**PCN Number:** 20141212001 **PCN Date:** 12/16/2014

Title: CC102x/CC1150 Orderable Part Number Retirement and Replacement

**Change Type:** Orderable Part Number Retirement and Replacement

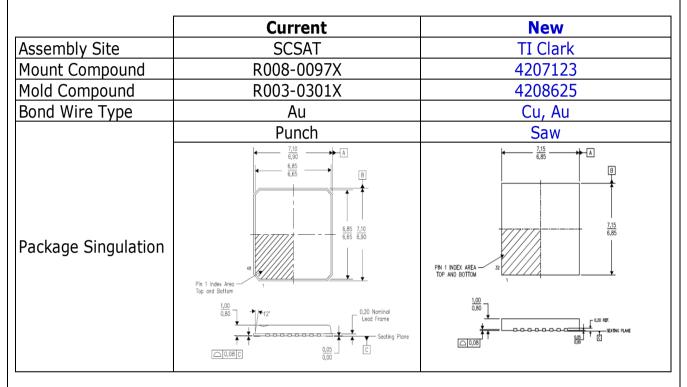
Note that the replacement product packages are sawn cingulated and are considered backwards compatible with the current punched packages, i.e. no PCB footprint change is necessary. Packing materials (shipping boxes, tape & reels, etc.) at the additional site will be consistent with materials currently in use at the current site.

Note also that the material sets of the replacement products are changing per the below:
